**PLANNING BOARD AGENDA**  
**JUNE 10, 2021 – 7:00 P.M.**

Re: Hirsch Site Plan – Addition to Building  
311 Drewville Road  
T.M. 66.13-1-7

**RESPONSE TO COMMENTS PLANNING BOARD MEETING May 26, 2021**  
**Swee, 2 Lot Subdivision, Hitchcock Hill Road**  
**Carmel (T), TM # 53.-2-79.1**

**PROPOSED SITE PLAN**

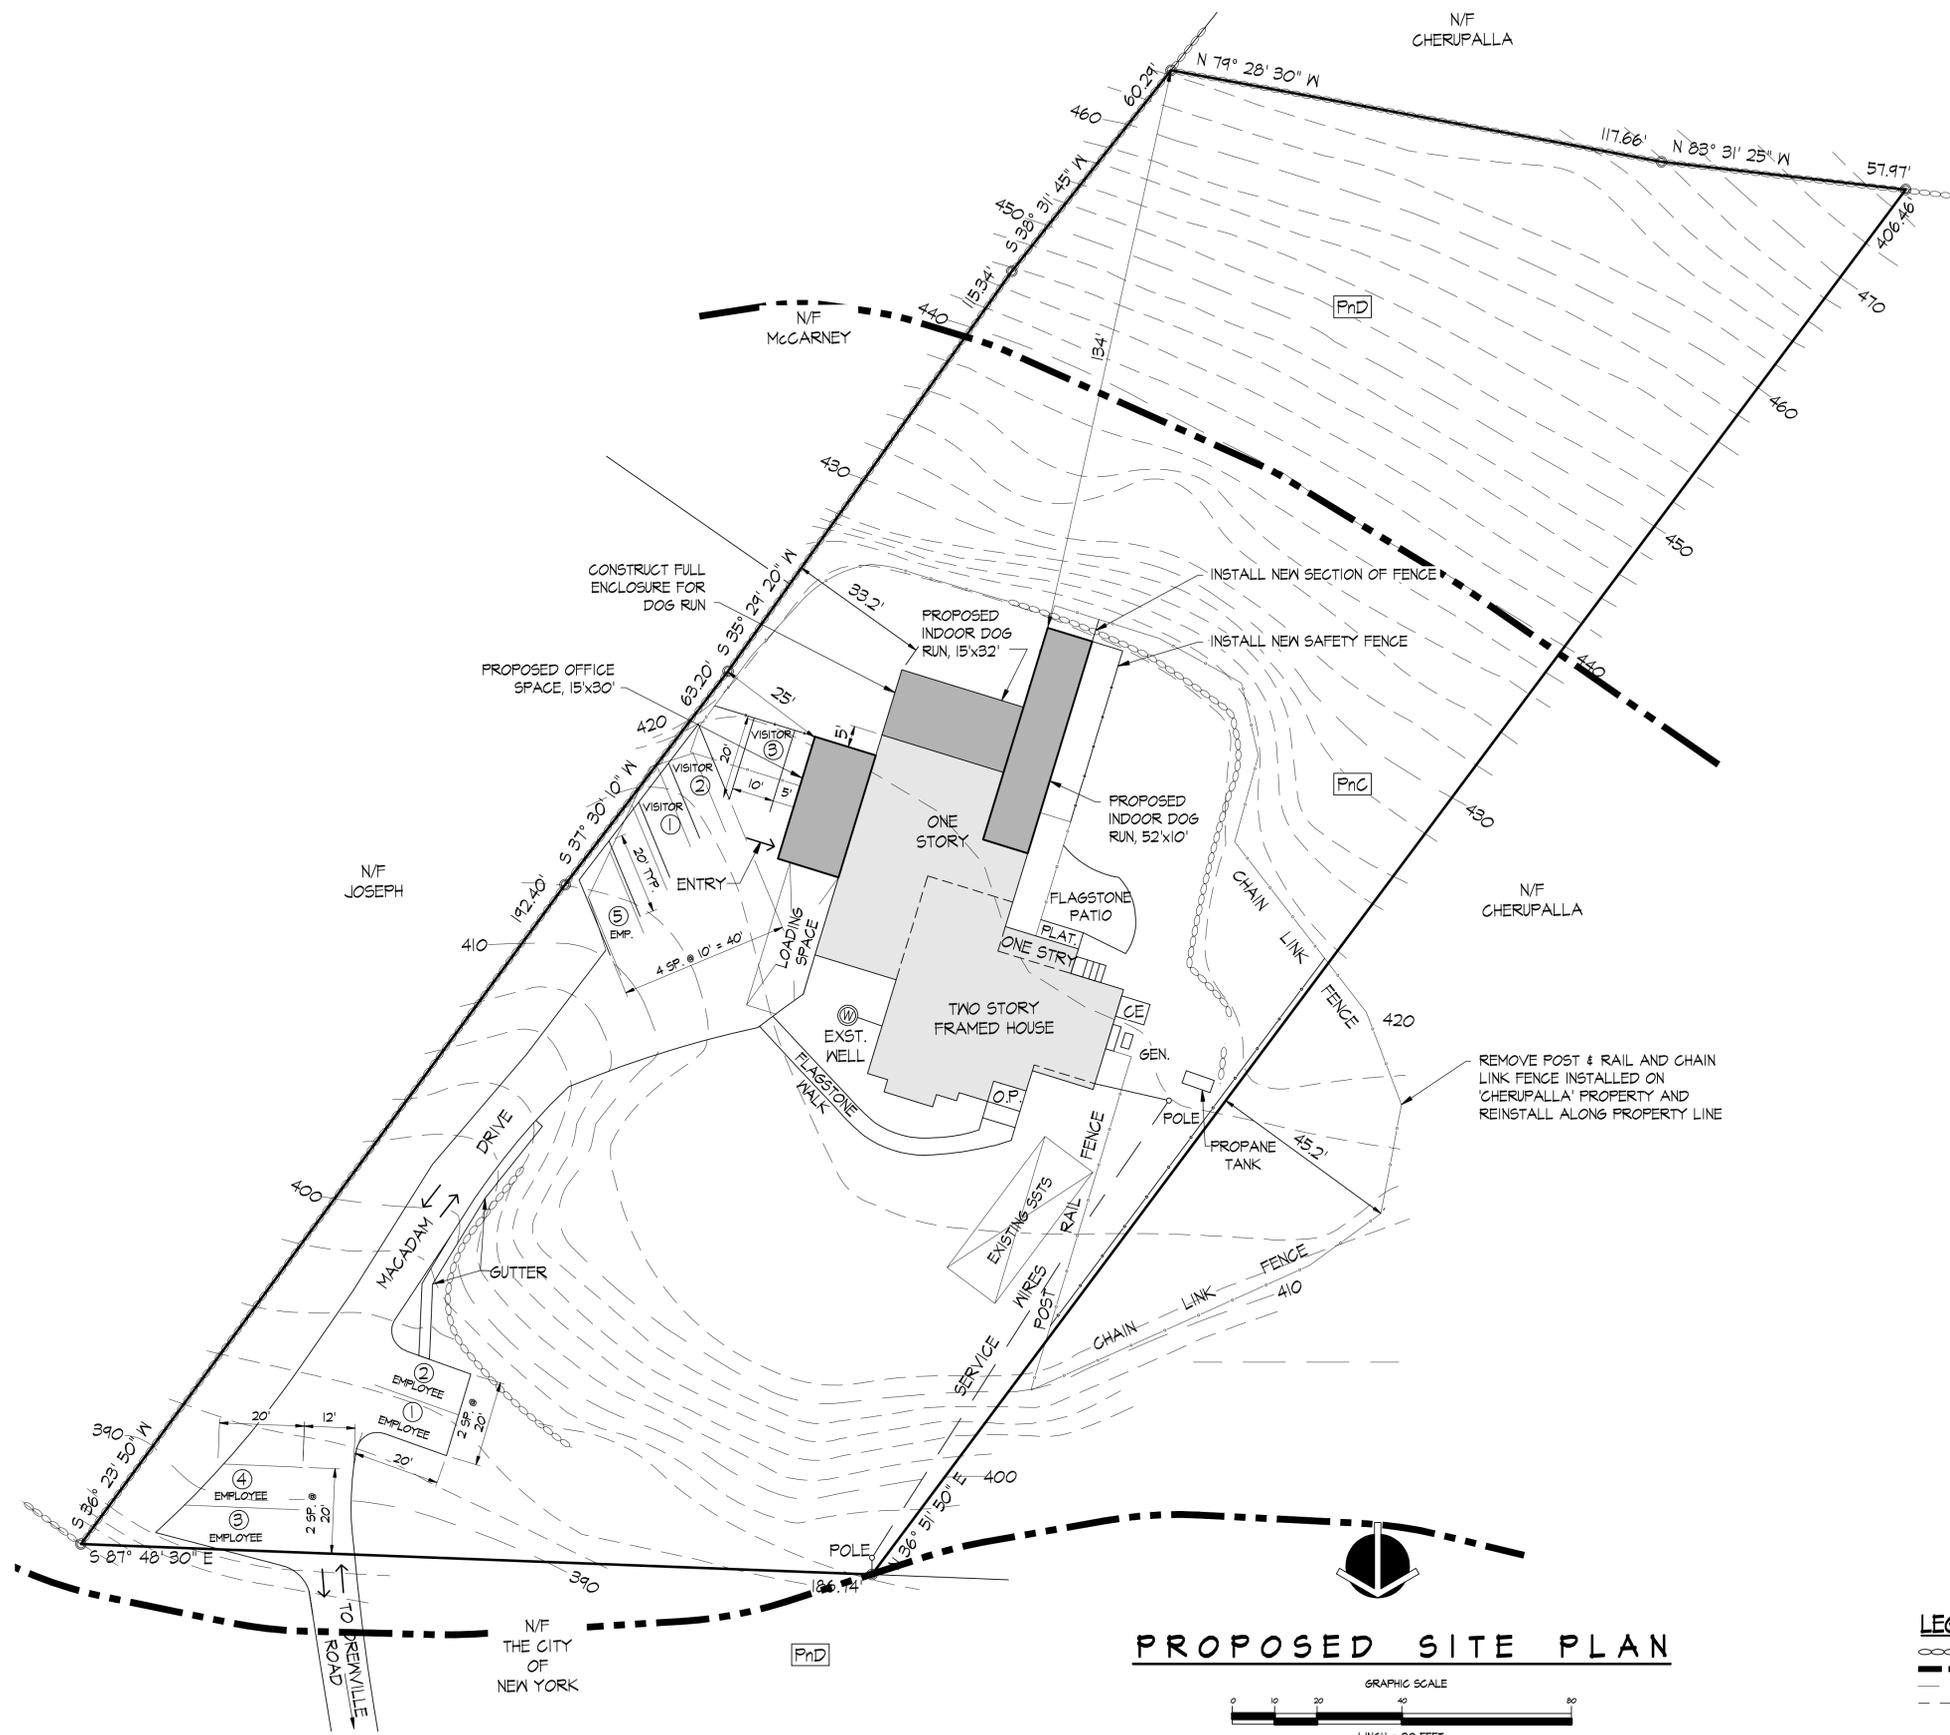
Town Planner:

2. We have discussed the off street parking with the Building Inspector and it was determined to use "all other non residential" for the calculation which will be 1 space for each 200 square feet of gross floor area.

3. The site plan note has been revised to reflect that the maximum number of employees working at the same time is 5 to 6. Therefore there are 6 employee parking spaces and 3 visitor parking spaces.

4. The parking spaces in the upper portion of the lot have been revised to show 10 foot by 20 foot dimensions.
5. The parking layout has been revised and the new layout accommodates a 24' aisle width.

6. The dog run has been decreased in length from 57' to 52' to avoid the stone wall.
7. A copy of the N.Y.C.D.E.P. invoice for access is attached.
8. Sound attenuation is proposed for the new construction.

11. The chain link fence that was installed on the (N/F) Cheropalla property was done by Ms. Hirsch's ex husband years ago. The fencing will be removed and reset on the Hirsch property.

SUBDIVISION PLAT  
 PREPARED FOR  
**DAVID & DEBRA SWEE**  
 BEING PARCEL 1 AS SHOWN ON A CERTAIN MAP ENTITLED "FINAL PLAT KNOWN AS THE SWEE SUBDIVISION, ETC." SAID MAP FILED IN THE PUTNAM COUNTY CLERK'S OFFICE, JULY 19, 2001 AS MAP NUMBER 1503-A.

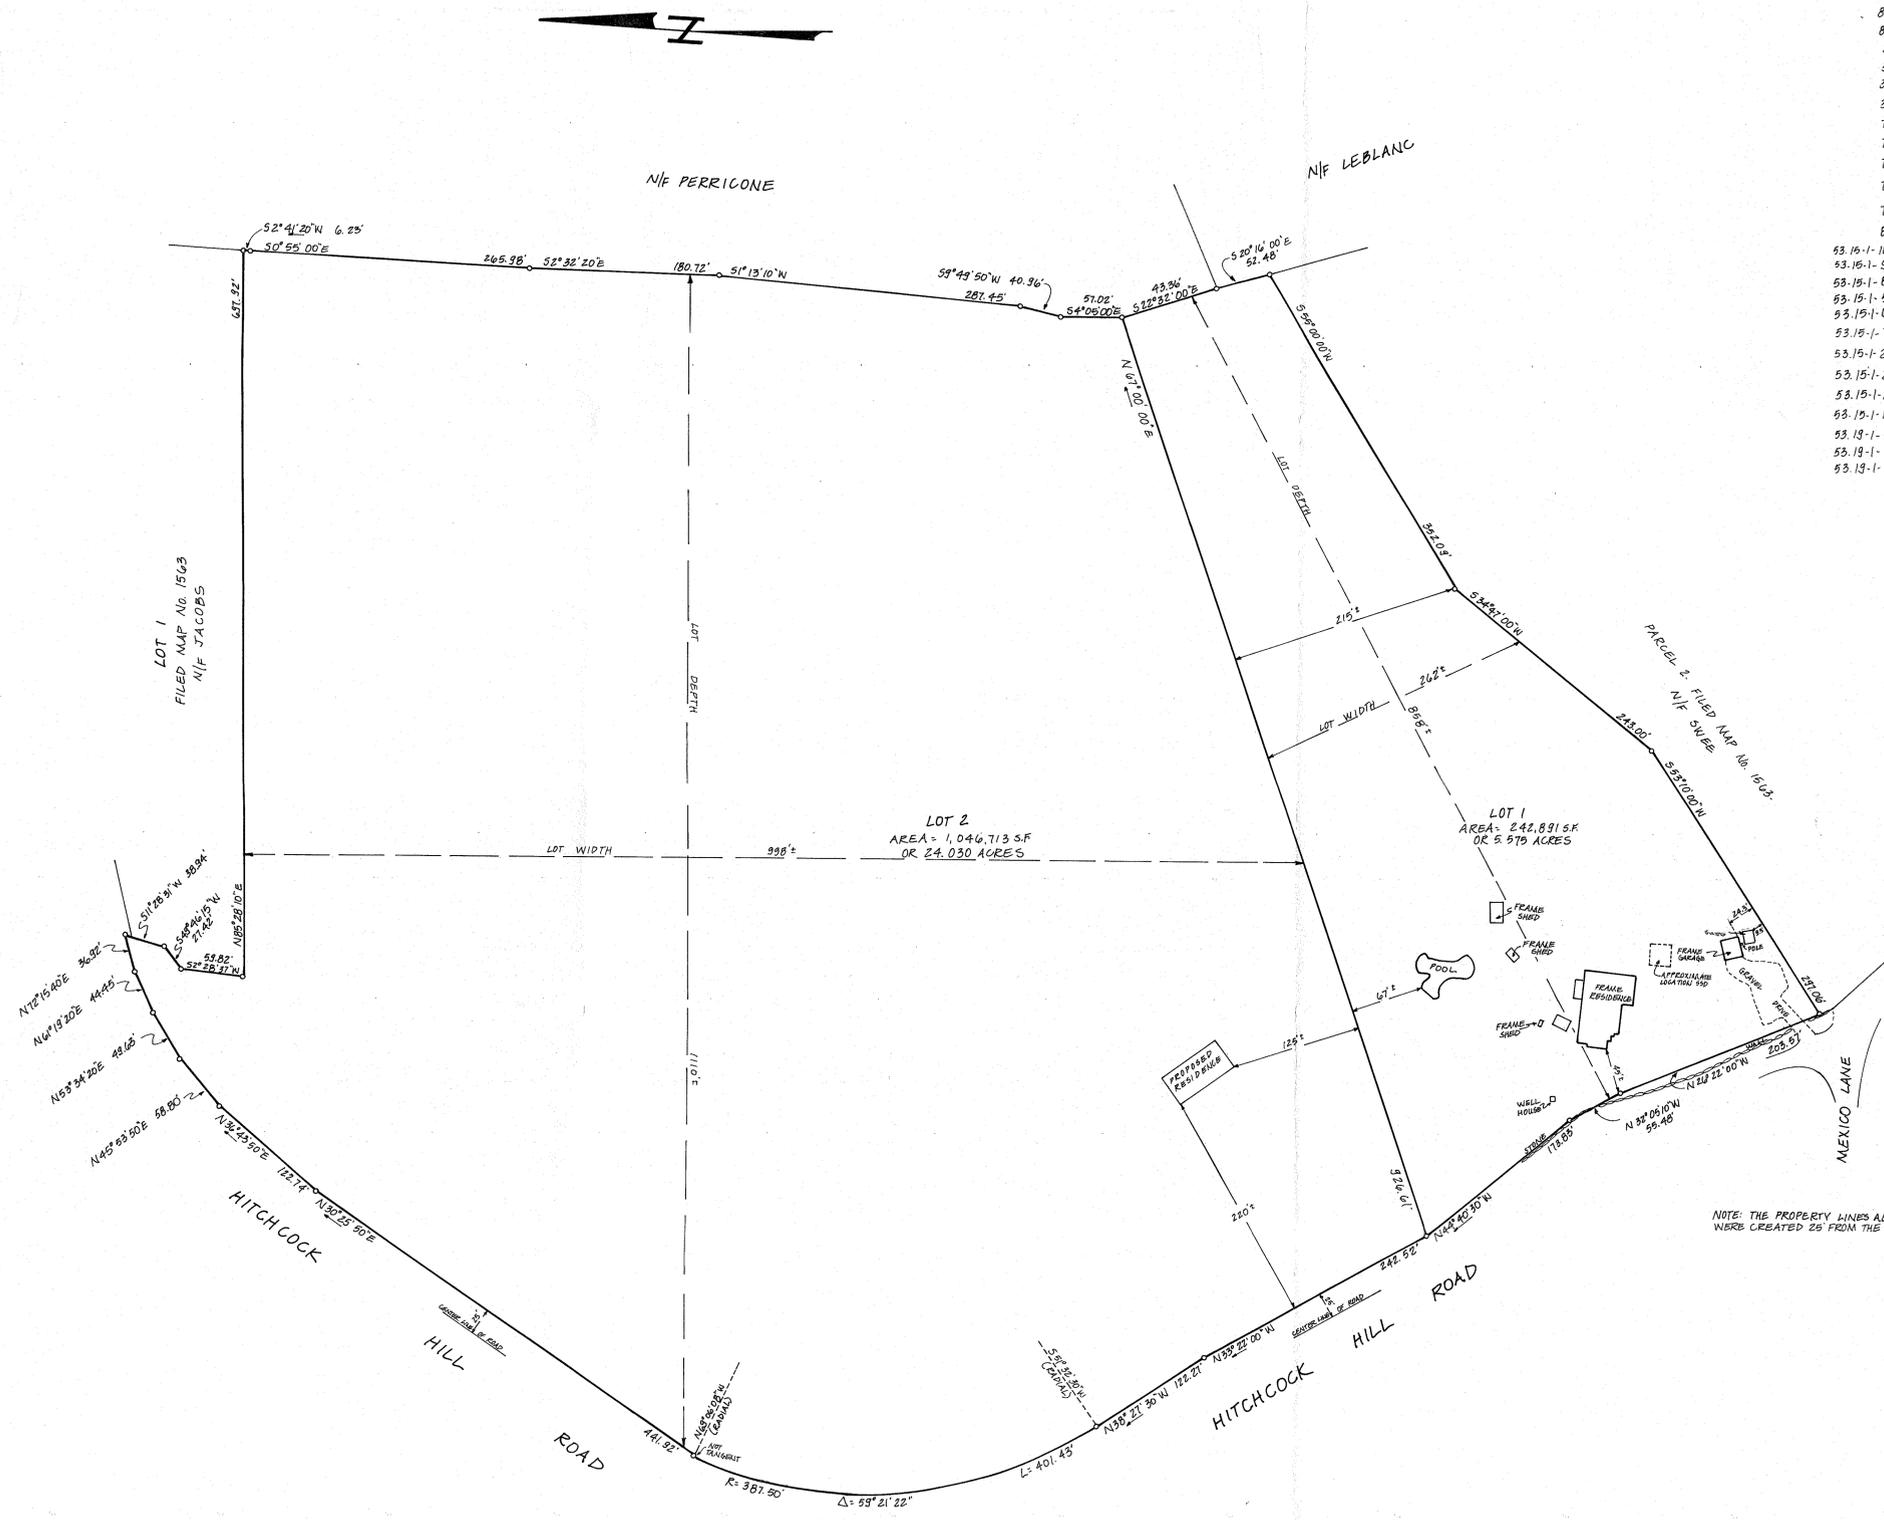
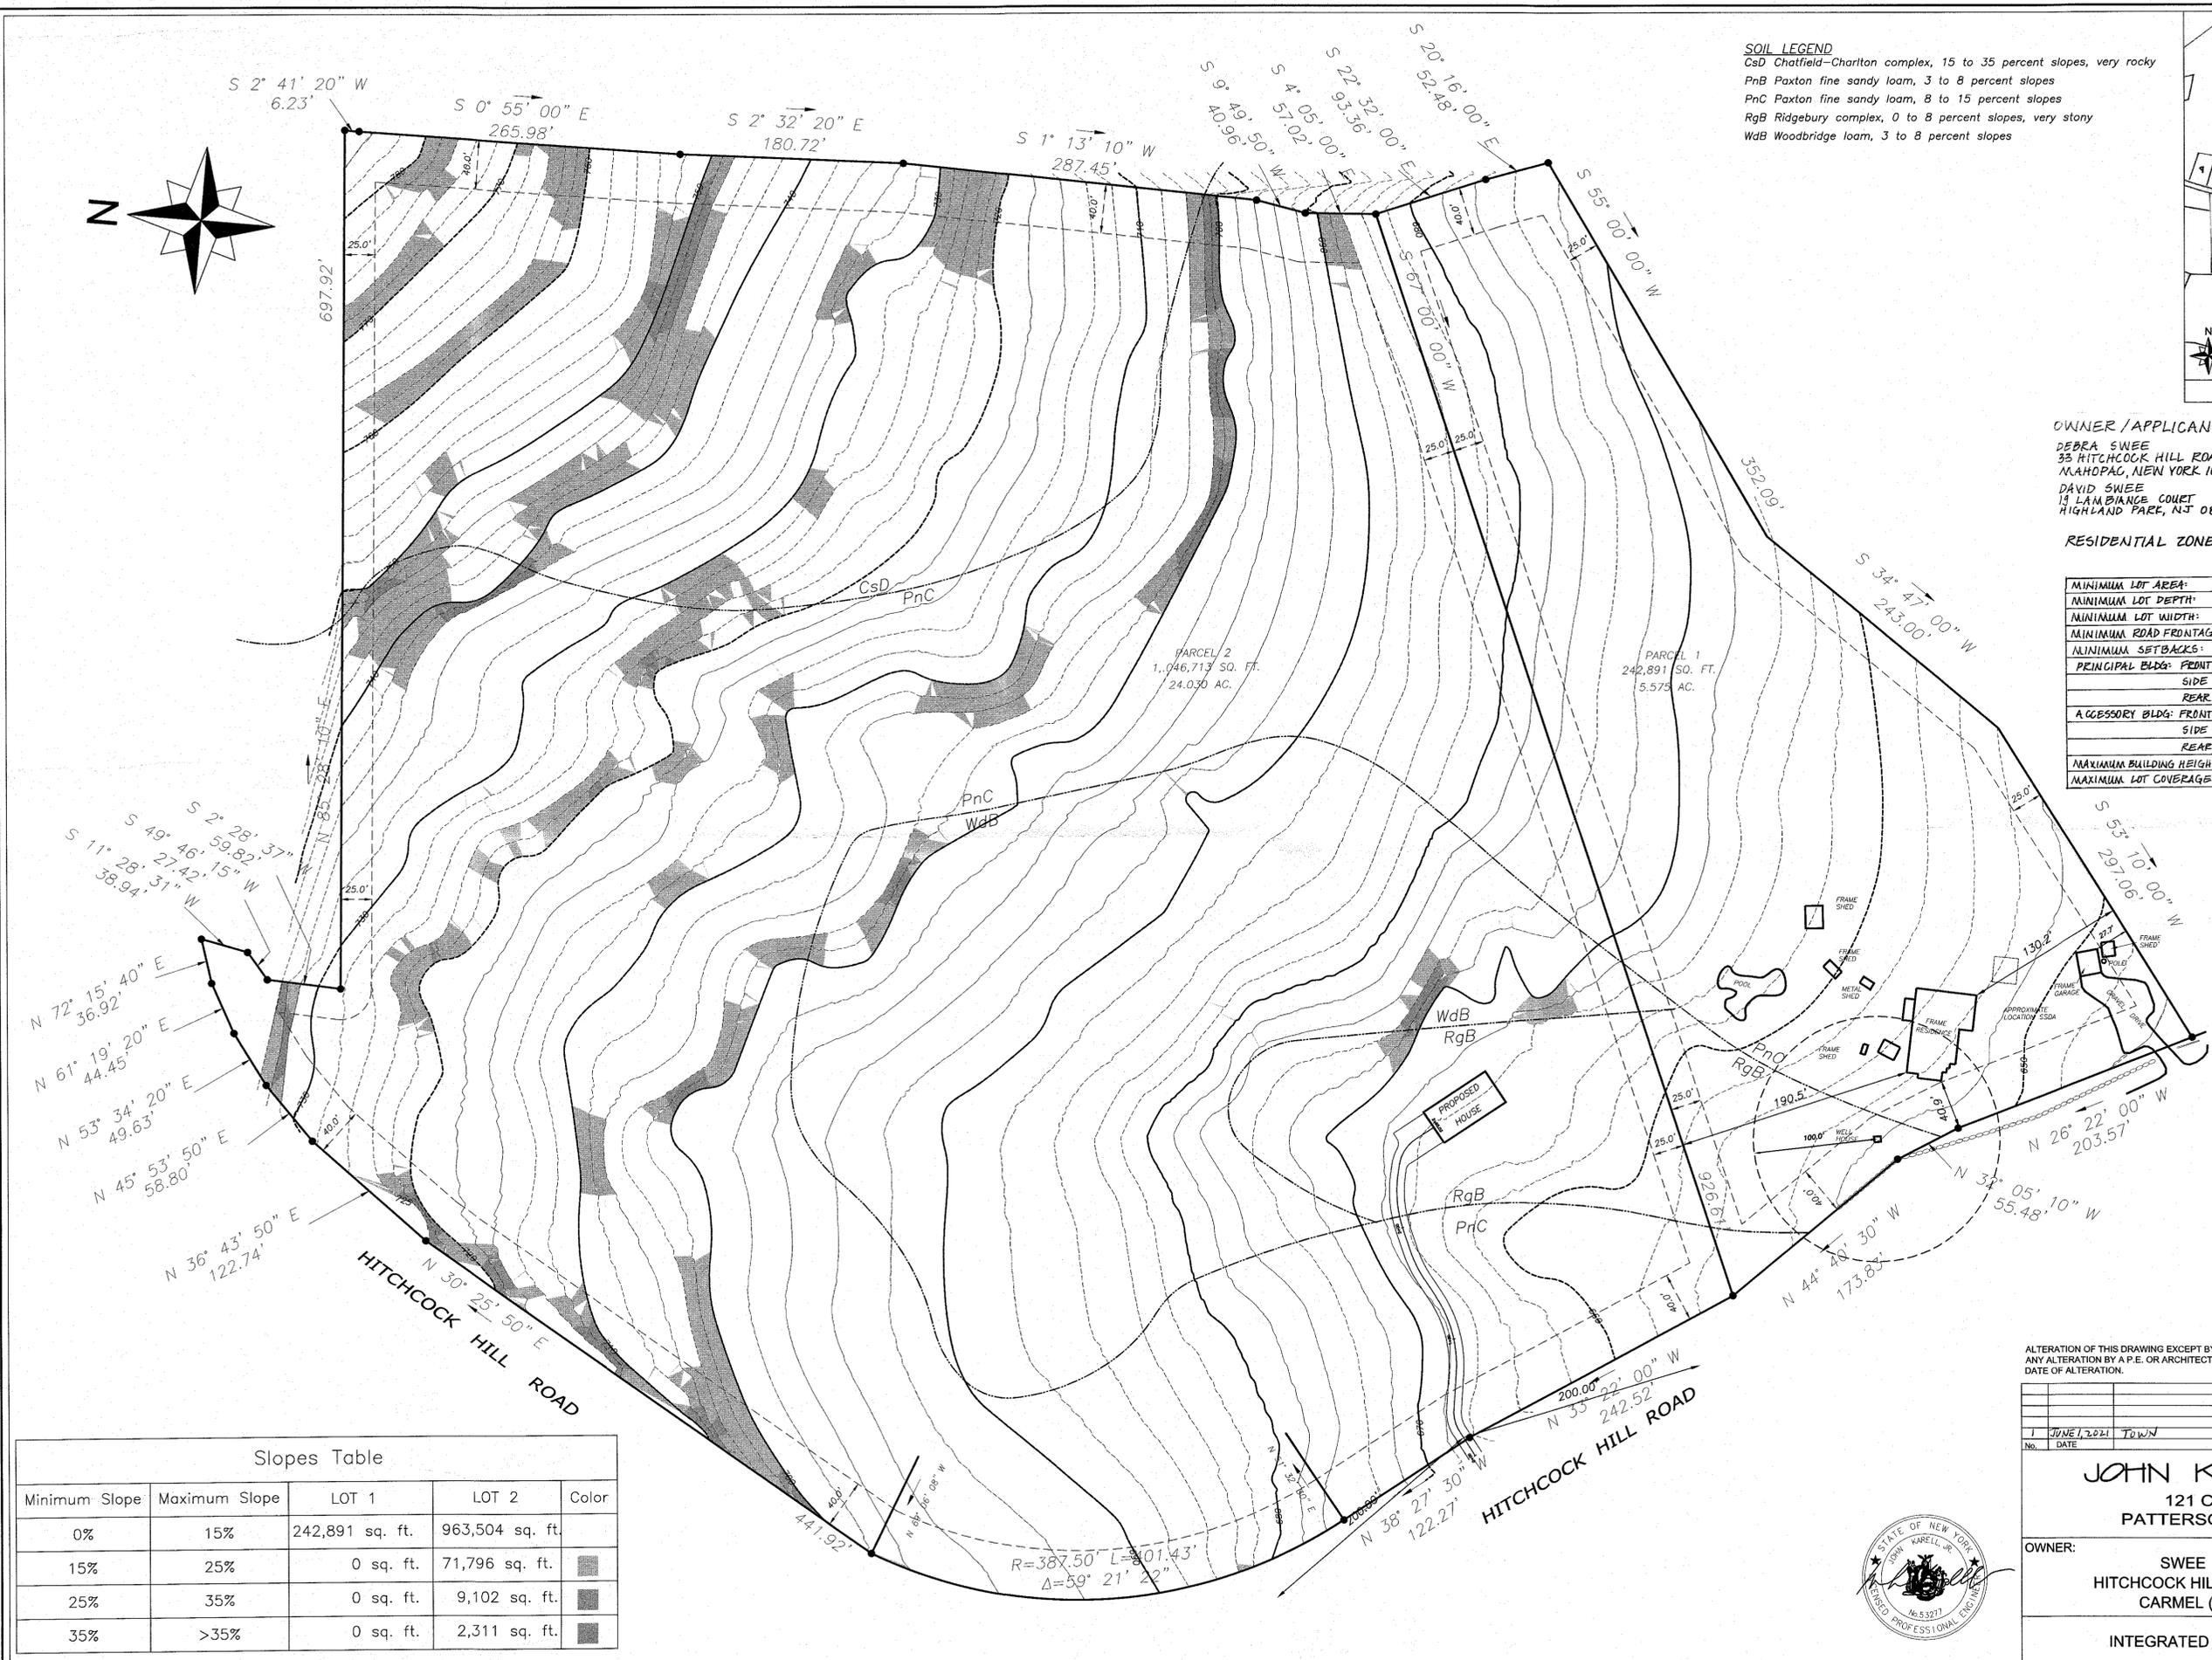
**Mike Carnazza, memo dated May 24, 2021**

1. Pursuant to comments from Mike Carnazza the plans have been revised to include depth and width lines on the subdivision plat and site plan. The values for depth and width have need added to the Zoning Schedule.
2. The existing building height has been added to the Zoning Schedule.
3. Lot frontage has been provided for both lots on the Zoning Schedule.
4. The Zoning Schedule has been added to the Site Plan.
5. There are no wetlands on this property.
